## North Westerly - PD 1<sup>st</sup> Review

To: Southern Land Company  
From: Aly Burkhalter, Planner  
Date: April 3, 2024  
Re: PD-001700-2024 North Westerly - PD  
cc: Kelly Driscoll, David Pasic, Jonathan Williams, Miguel Aguilar, Luke Bolinger, Kathy Kron, David Frank

# NORTH WESTERLY PLANNED DEVELOPMENT ZONING MAP AND GUIDE

### ZONING MAP

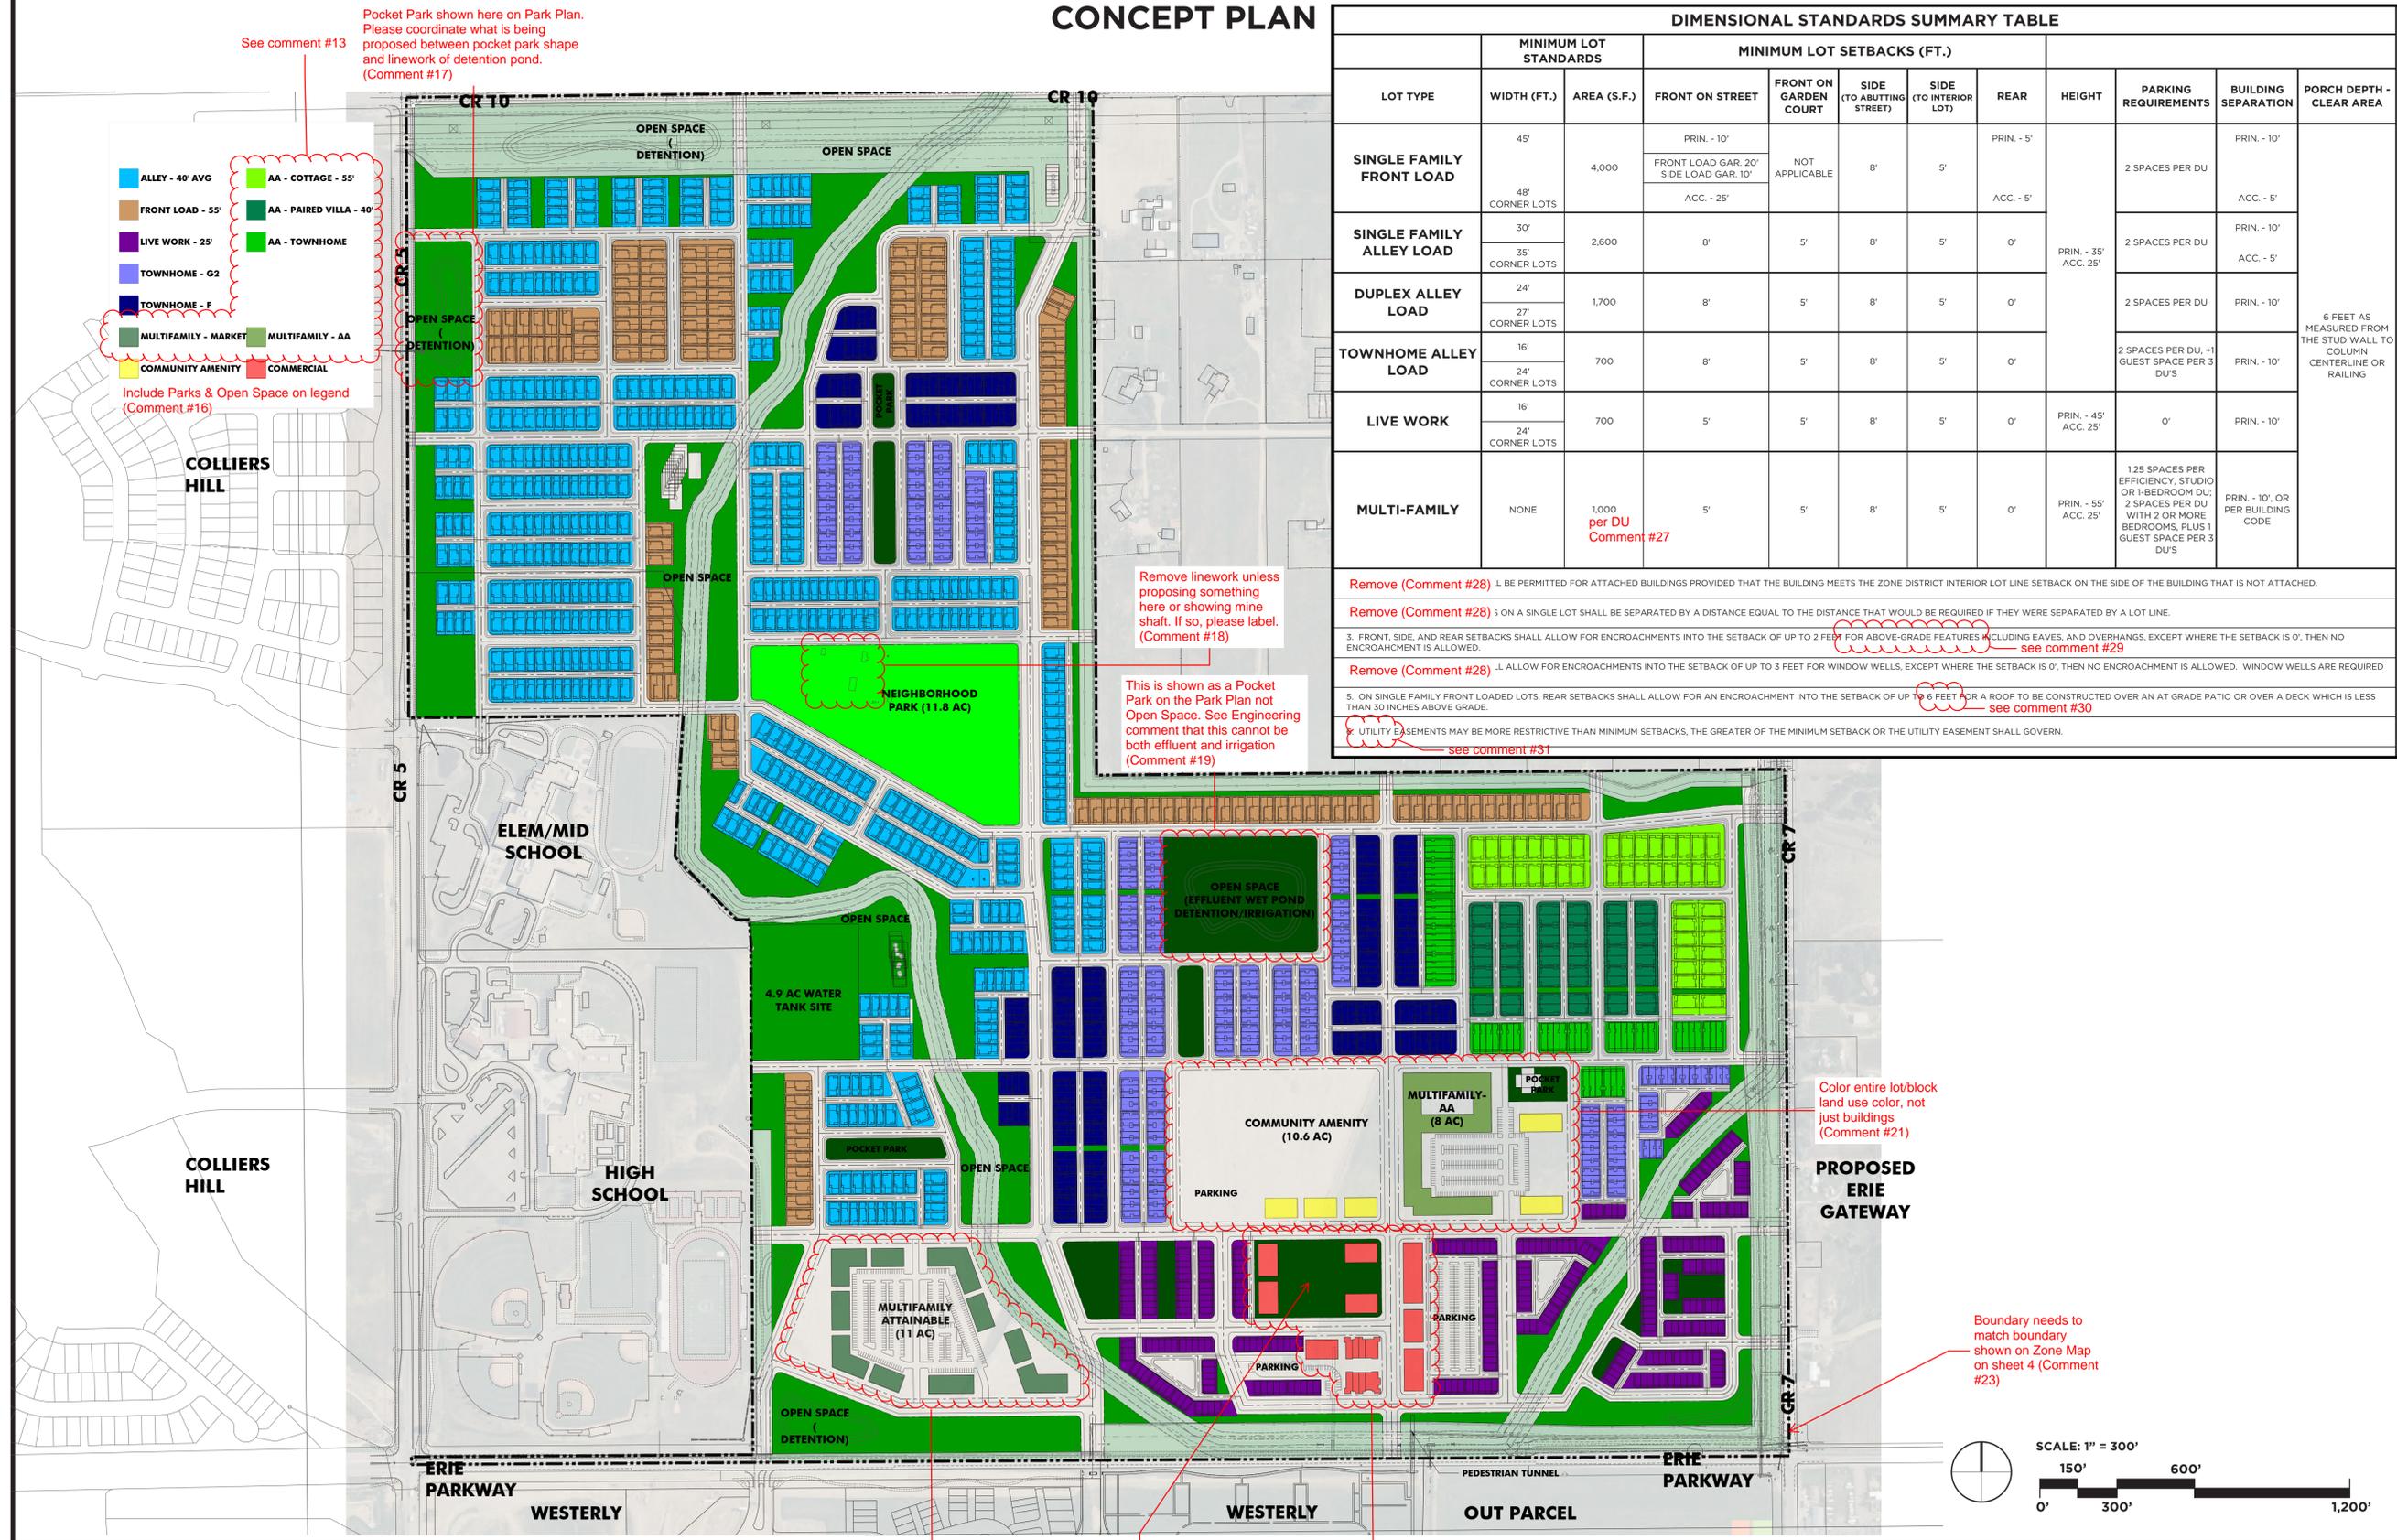
23. On concept plan, boundary needs to match boundary shown on Zone Map (sheet 4).
24. The Dimensional Standards Summary Table shall be provided on its own separate sheet from the Concept Plan. It shall include dimensional standards for commercial, mixed use, or community amenity. See additional comments below under #9c Building form/Characteristics Plan.

**COMMERCIAL  
DEVELOPMENT  
STANDARDS**

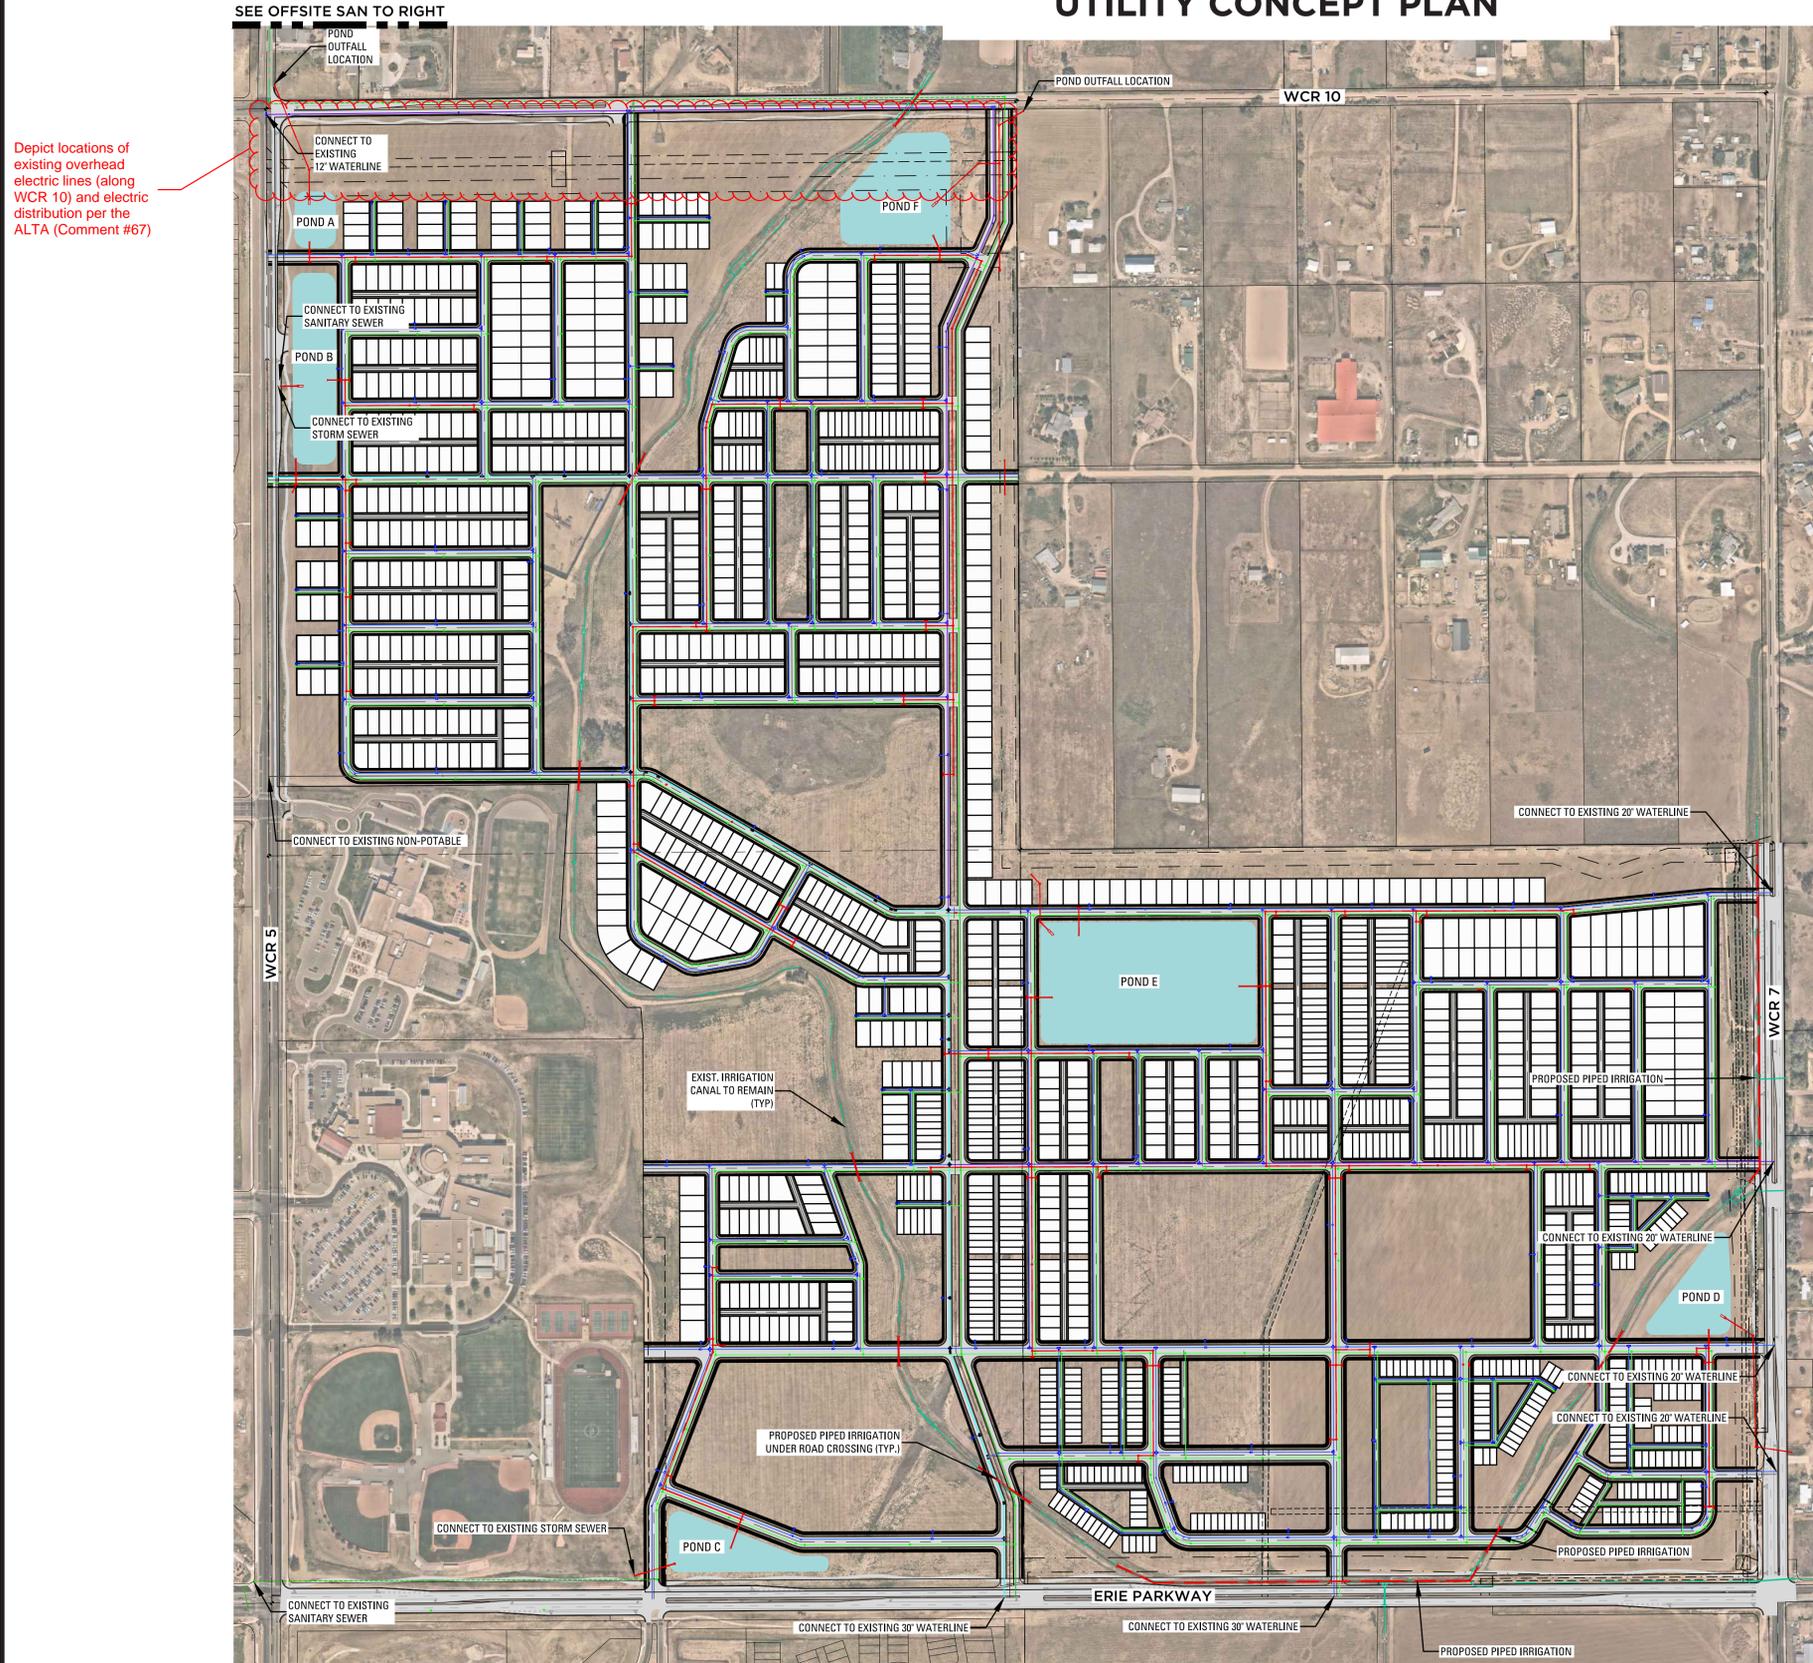
- d. Sheet 10-11 shall be labeled "Commercial Development Standards".
39. Please add a section for Community Amenity as it is a use on the concept plan.

## UTILITY CONCEPT PLAN

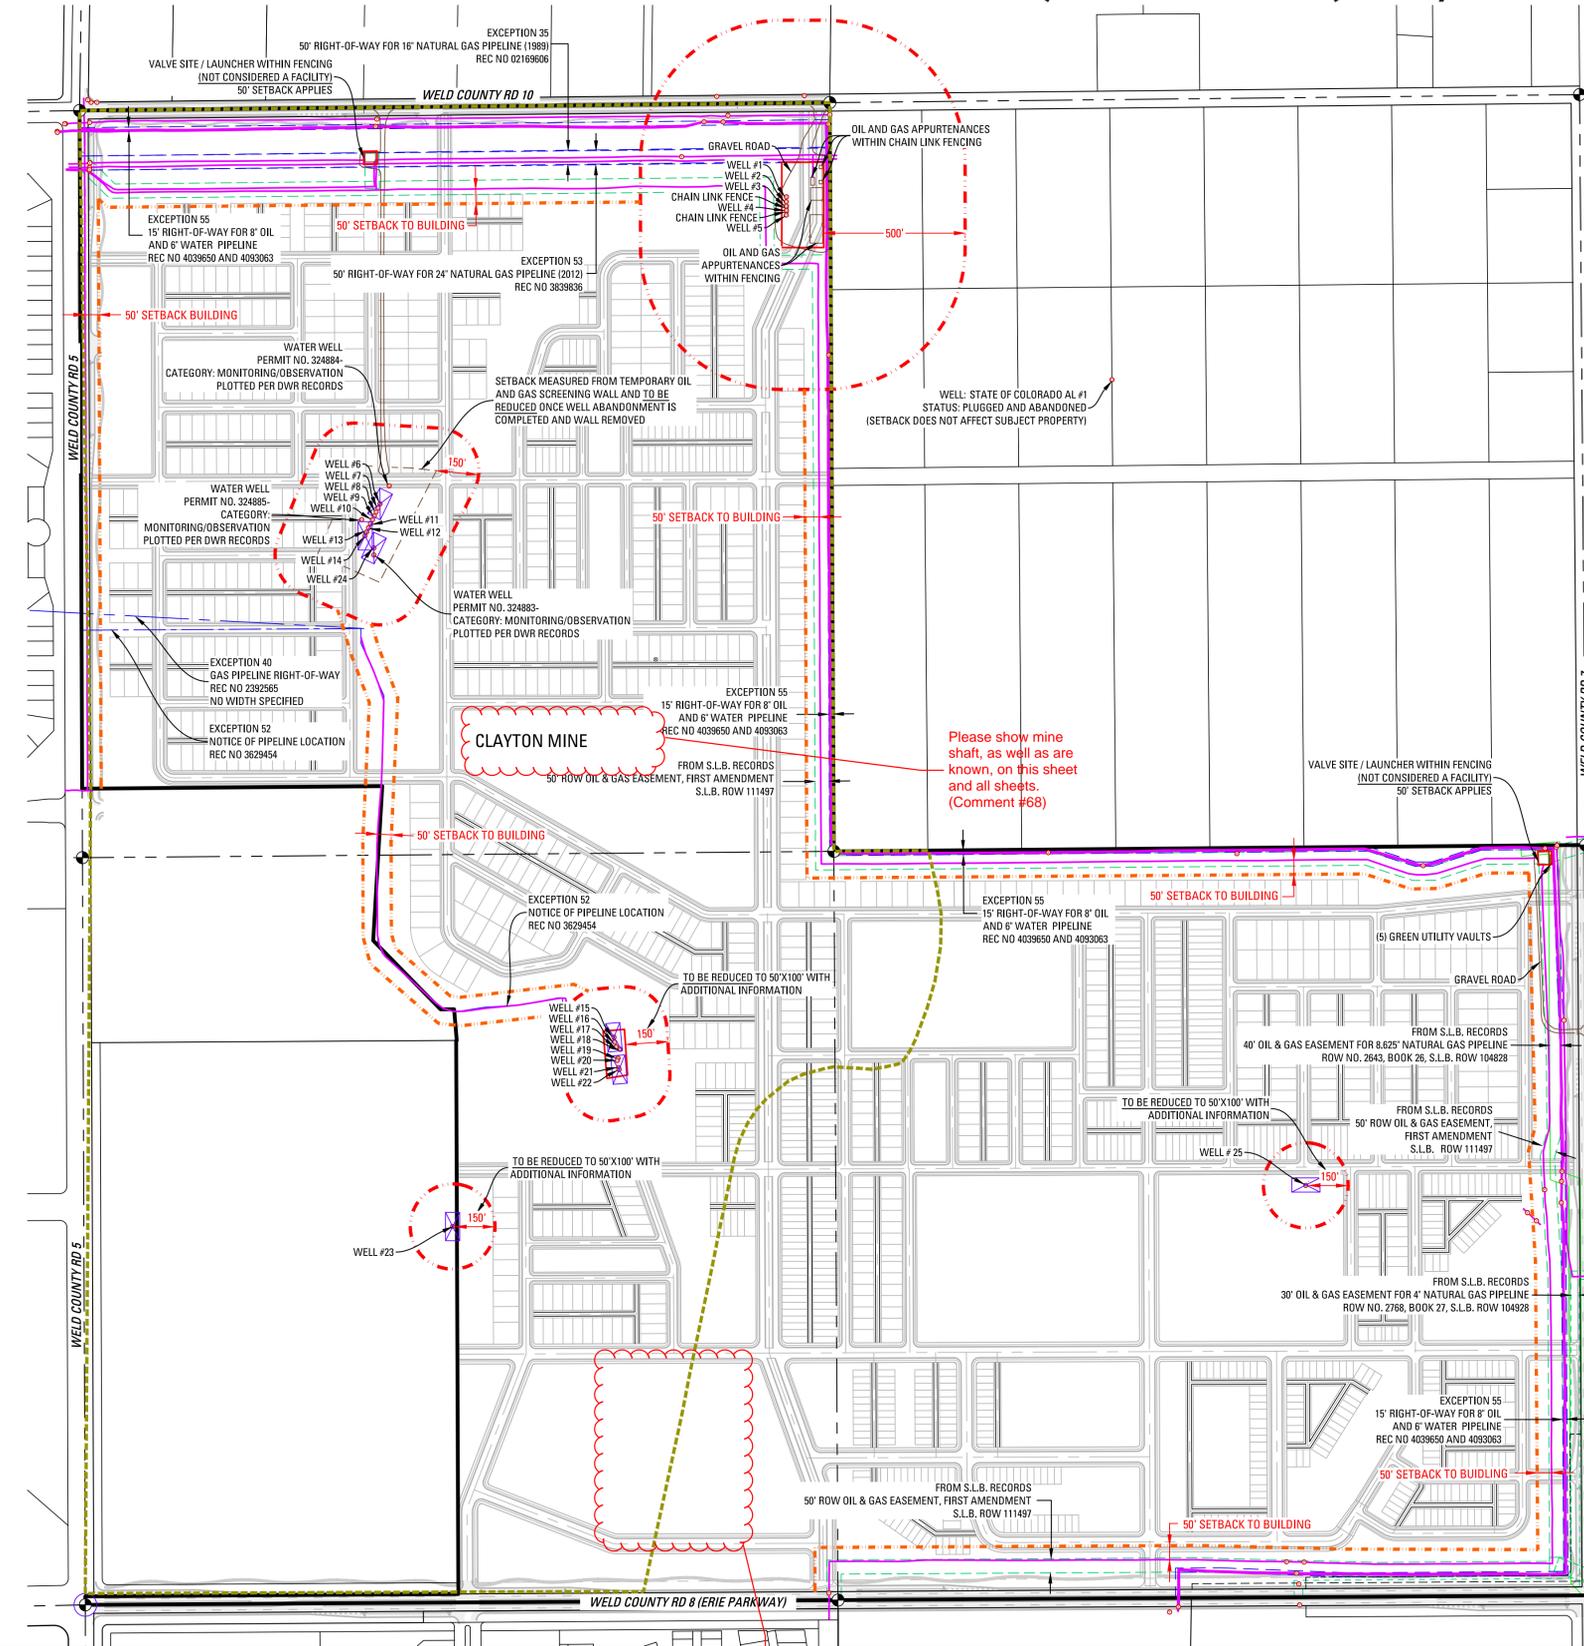
15. We have the following comments on Sheet 12, Utility Concept Plan:

- a. Ponds A and F are shown in a different location on Sheet 12 than they are shown on Sheet 5 or the Drainage Exhibit. All plans must match.
- b. Pond F is in an open space area with numerous existing utilities, including overhead electric. Verify that a detention pond is allowed within this utility corridor and that adequate clearance is available to construct and maintain a pond, including access, in this location.
- c. Several pond inlets are shown too close to the pond outlet structures. This would result in the ponds being short circuited and not performing as intended to remove sediment and debris. See MHFD Urban Storm Drainage Criteria Manual (USDCM) Volume 3, Chapter 4, Section T-05 Extended Detention Basins for more detail.
- d. The building locations shown on Sheet 12 are different in several areas compared to Sheet 5. Revise to match.
